Government of India
Ministry of Railways
Research, Designs & Standards Organisation
Manak Nagar, Lucknow - 226 011

No. EL/3.2.5/J3
24.1.1992

Modification Sheet No. RDSO/WAM4/168

- 1. Title :** Modified adjustments shim and silirite shim for commutating pole core of TAO 659 Traction Motor.
- 2. Application :** All electric locomotives viz., WAM4, WAP1, WCAM1 & WAG5 fitted with TAO 659 Traction Motor.

REF:-	SCALE:- 1:1	APPROVED :-	FOR DG.
ADJUSTMENT SHIM FOR COMMUTATING POLE OF TAO-659 TRACTION MOTOR.			
RDSO. ELECT. DTE.		SKEL-4081

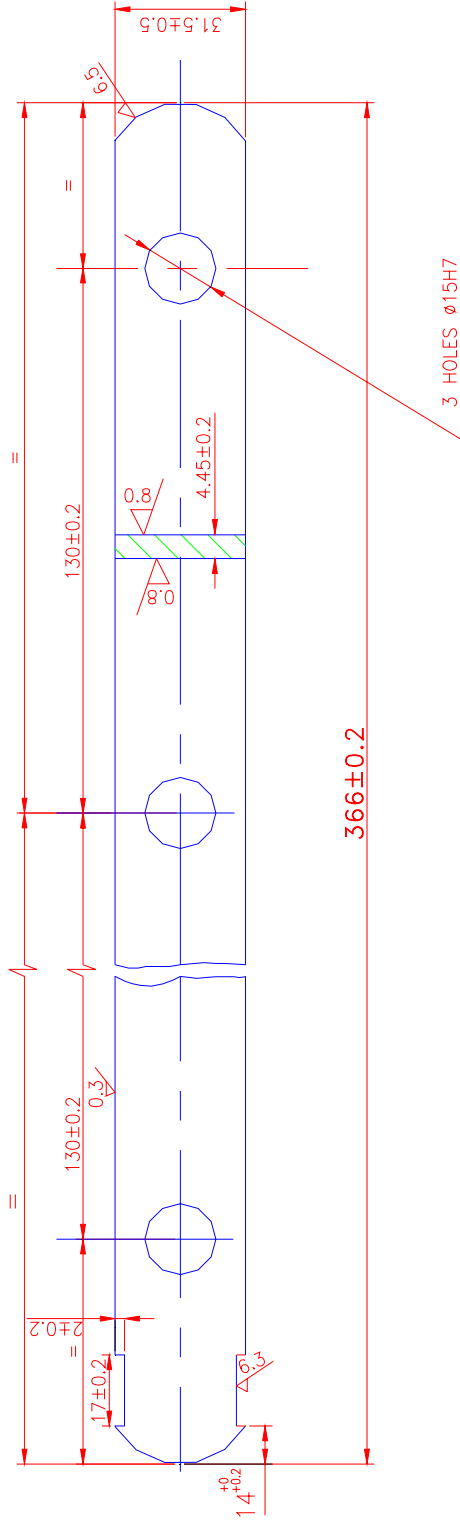
- 3. Object :**
 - 3.1 :** At present adjustment shim & silicate shim for commutation pole is being provide as per CLW Drg. No.3 TWD.092.173. The adjustment shims have sharp corners and likely to damage insulation partly at the time of assembly of coils. The sharp corners are also contributing to the failure of coils earthed in service due to vibration.

- 3.2 :** It is also observed that in some cases the adjustment shim are projecting over and above the pole core punching. This also leads to partly damage of the coil insulation during assembly in service. The situation may also contribute to earthing of coils in service when coils are subjected to vibration.

- 3.3 :** The present modification intends to adopt the modified profile of adjustment shim/silirite shim for compole to ensure that there are no sharp corners and avoid any possible damage during assembly/service.

- 4. Details of Modification**
 - 4.1 :** Remove the present adjustment & silirite shim from compole core assembly
 - 4.2 :** Provide the modified adjustment & silirite shim having no sharp corners and smooth profile as shown
DRG No. SKEL - 4081 & SKEL - 4082.

- 4.3 : The modified adjustment & silirite shim should be dye punched and have smooth surface/edges.
- 4.4 : check adjustment & silirite shim are not projecting beyond core.

- 4.5 : Material for the adjustment silirite shim should be got checked as per relevant specification before acceptance of the material. Thickness of the adjustment shim should be such so as to ensure air gap within the limits laid down.
